**VEHICLE FACTORS GROUP CHAIRMAN'S
FACTUAL REPORT**

Vehicle Attachment – MCI Vehicle Reports

HWY17MH005

Service Bulletin No. 118

Figure 2. Brake System With E-15/ E-15R Brake Valve and Parking Brake Interlock.

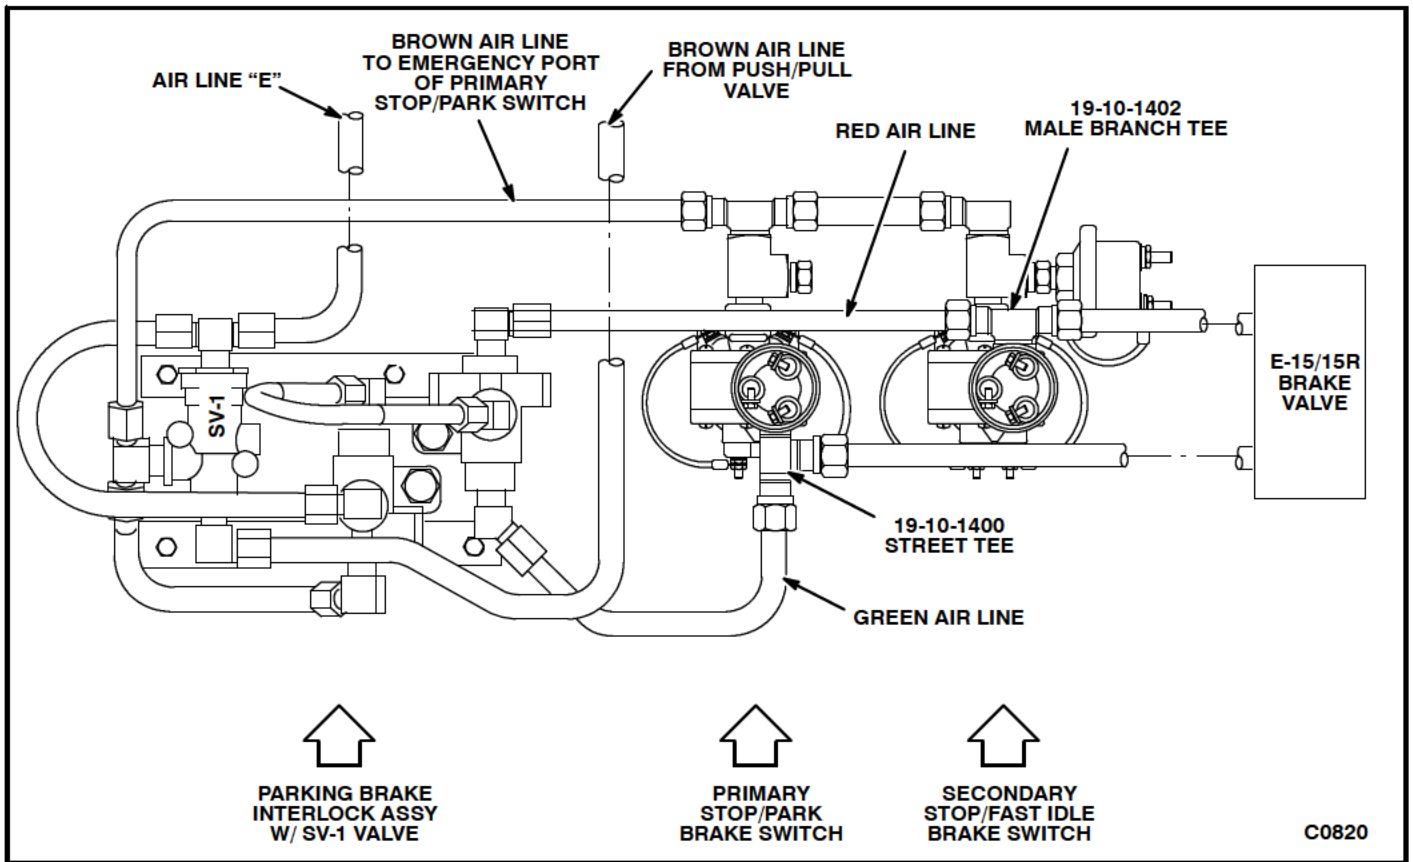
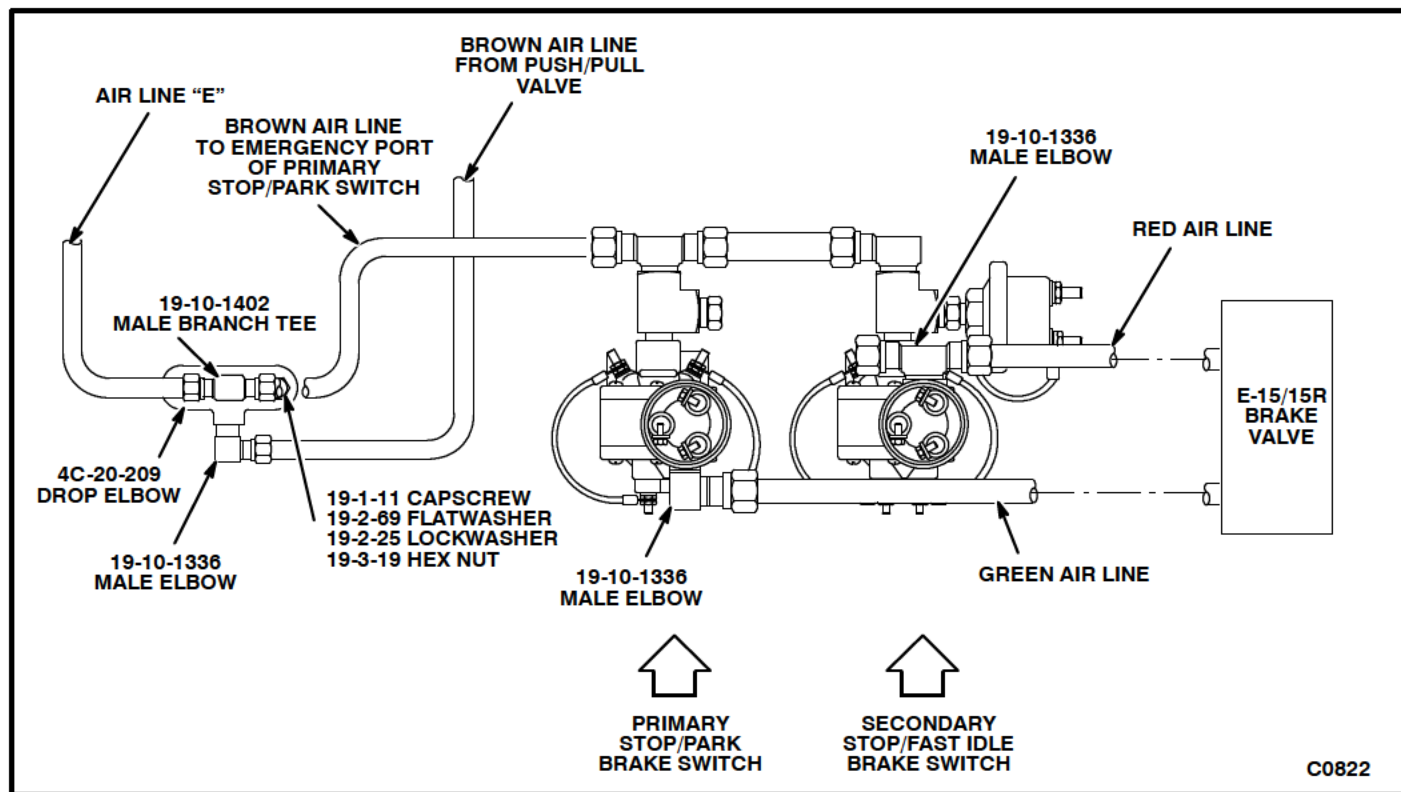
Effective with unit 48127*, MCI redesigned the braking system on 102D3 and 102DL3 coaches by removing the interlock between the parking brake and service brakes.

b) On coaches having an E-15 or E15R brake valve, disconnect the air lines to the 19-10-1400 street tee on the primary stop/park switch assembly and from the 19-10-1402 male branch tee on the secondary stop/fast idle switch assembly (see Figure 2). Replace the tees with 19-10-1336 male elbows (see Figure 4). Connect the red and green airlines running between the switches and the E-15/E-15R brake valve to the newly installed 19-10-1336 elbows (see Figure 4).

8. Install a 19-10-1336 male elbow in the end port of the 4C-20-209 drop elbow. Orient the 19-10-1336 elbow so that its open end is pointing to the right. Install a 19-10-1402 male branch tee in the top port of the elbow, orienting it so that the long dimension of the tee is parallel with the mounting flange of the drop elbow.
9. Install the 4C-20-209 drop elbow with the added fittings in the same approximate location that was occupied by the interlock assembly, making sure it is located such that all of the brown airlines can be easily connected to it. Install the drop elbow with its end port and the 19-10-1336 elbow downward. Use the capscrews, nuts and washers from the kit to install the drop elbow as shown in Figures 3 & 4.

Figure 5. Old Tag Axle Brake Line Installation With Regulator Valve.

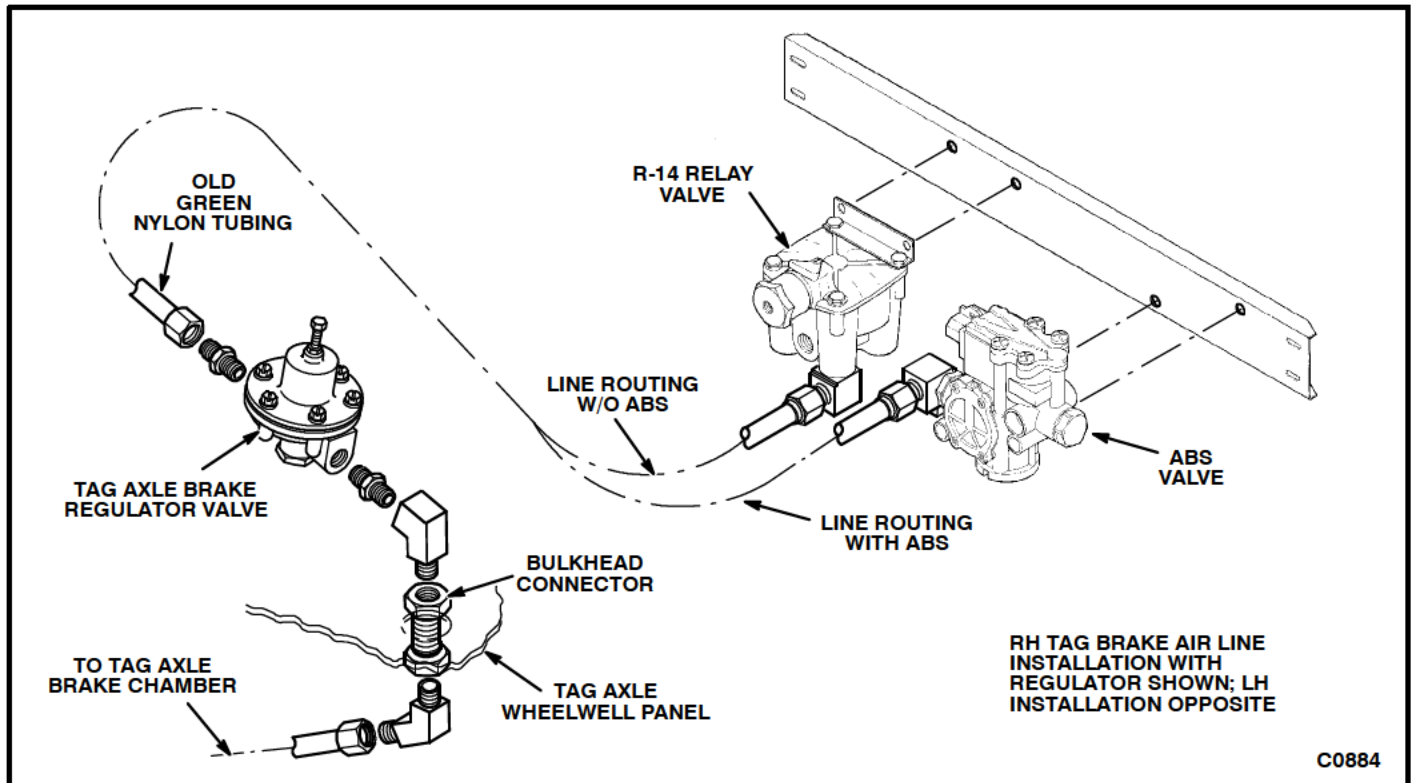
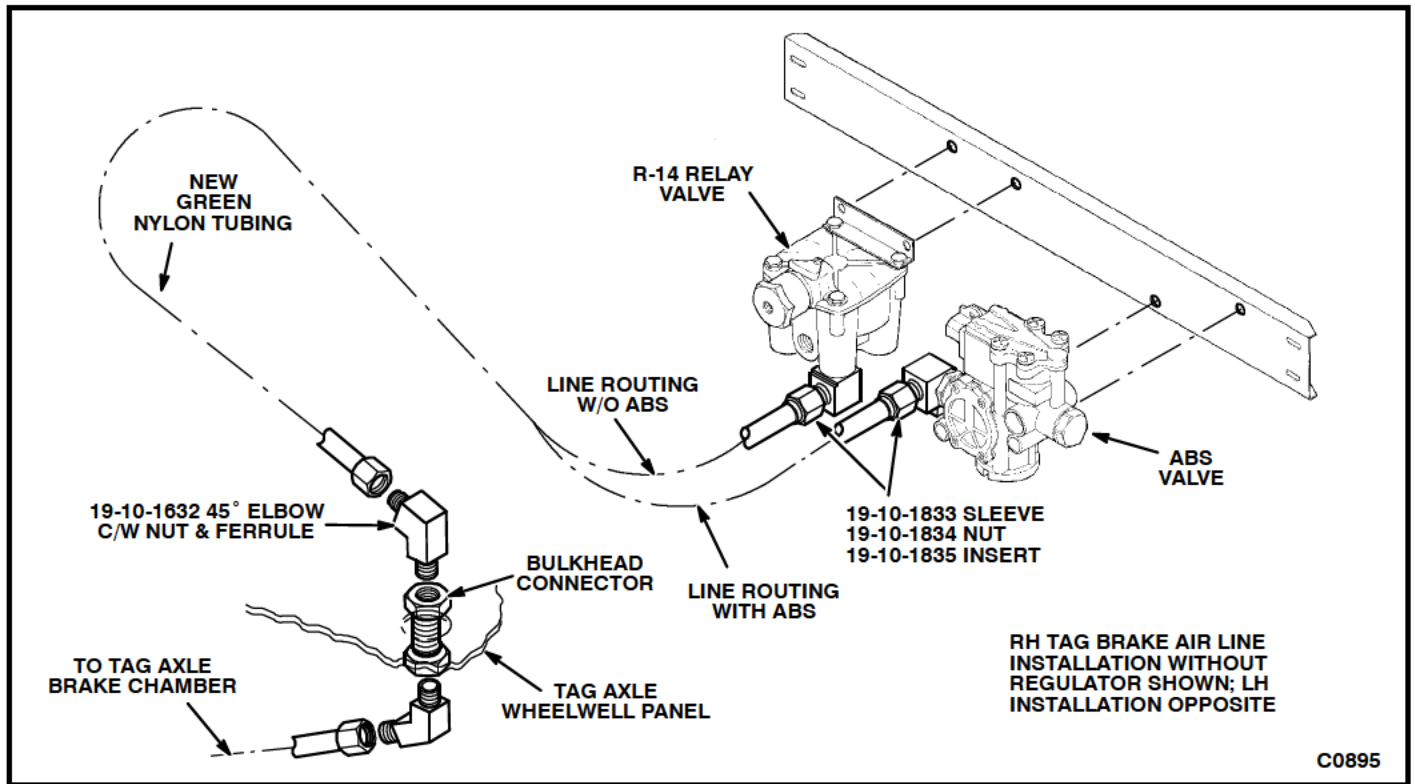
On some 102D3 coaches, removal of the parking brake interlock results in noise from the tag axle brake regulator valve. DOT braking performance standards are not impaired by removing the tag axle brake regulator valves from 102D3 coaches. As a result, the tag axle regulator valve was removed from 102D3 production coaches effective with unit 48107*.

1. Turn the main battery switch to "OFF," apply the parking brake and chock the coach wheels.
2. Remove and discard the 1/2" green nylon airlines connecting the the R-14 valve to the 28 psi tag axle brake regulator valves. See Figure 5.
3. Remove both regulator valve assemblies complete with all fittings from the wheel well bulkhead connectors. Do not remove the bulkhead connector. See Figure 5.

4. Install a 19-10-1632 male 45° elbow into each of the bulkhead connectors, and using the nuts and ferrules supplied with the elbow, connect a 24" or 27"* length of new 1/2" green nylon airline from the kit to each elbow. See Figure 6.
*Use 24" lengths of tubing with an anti-lock brake system, 27" lengths if there is not an anti-lock brake system.

5. Using the 19-10-1833 sleeves, 19-10-1835 inserts, and 19-10-1834 nuts from the kit, connect the other ends of the new airlines to the ABS valve on coaches with anti-lock brakes or to the R-14 valve on coaches without anti-lock brakes. See Figure 6.

Figure 3: Diode Assembly Installation

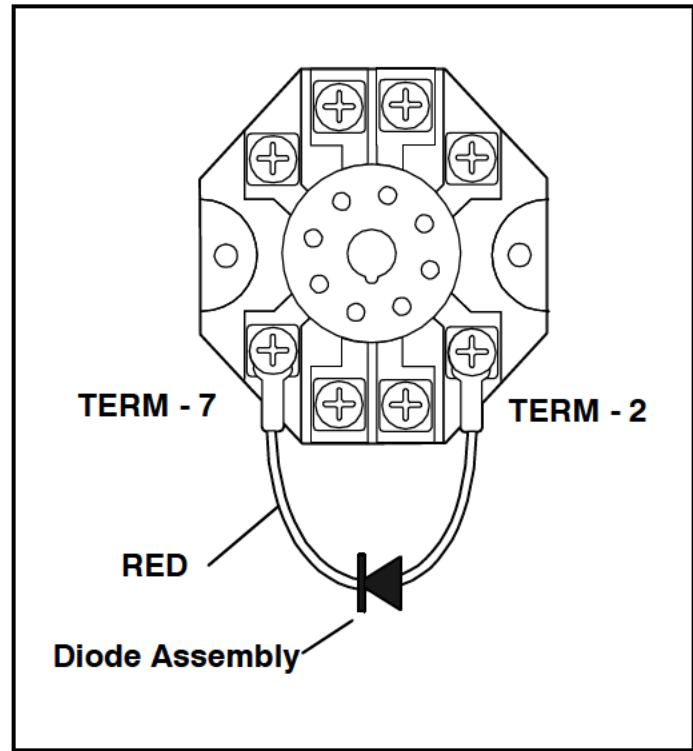
5. Install the diode assembly to the neutral start relay located in the rear junction box, which is accessible through the left-hand side engine service door (Figures 1, 2 and 3).

Note: Connect the red-coloured terminal to Terminal 7 on the relay, per Figure 3. Installing the diode backwards will destroy the diode.

Figure 4: ECU Isolation Details

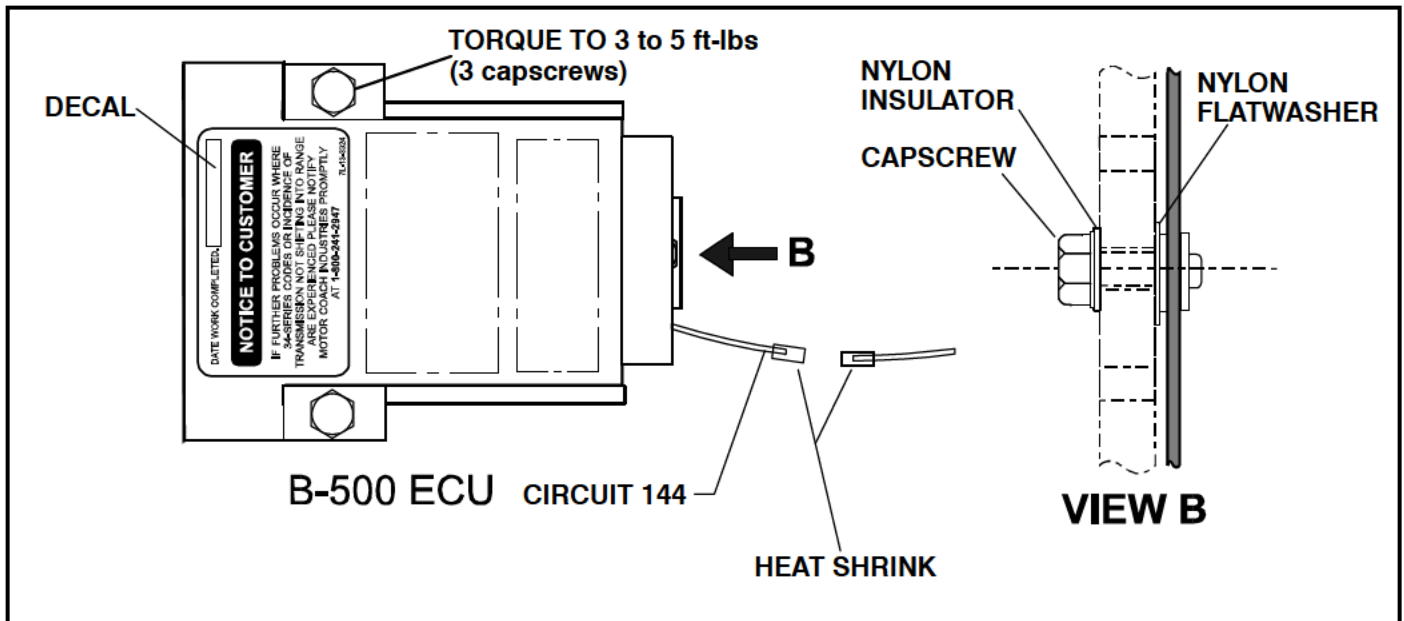
Install the following retrofit kit to electrically isolate the B500/R and HD4060/R ECU.

8. Reinstall the ECU, using the existing capscrews and the nylon insulators and washers supplied as shown in Figure 4. Torque the capscrews to 3 to 5 ft-lbs torque.

9. Cut Ground Wire 144 approx. 2 inches (5 cm) from the ECU connector and heat shrink both ends per Figure 4.
10. Check the ECU case with an ohmmeter to ensure discontinuity from the coach frame.
11. Affix the decal to the ECU as shown in Figure 4.
12. Enter the date on the decal in the box provided to show when the work was done.
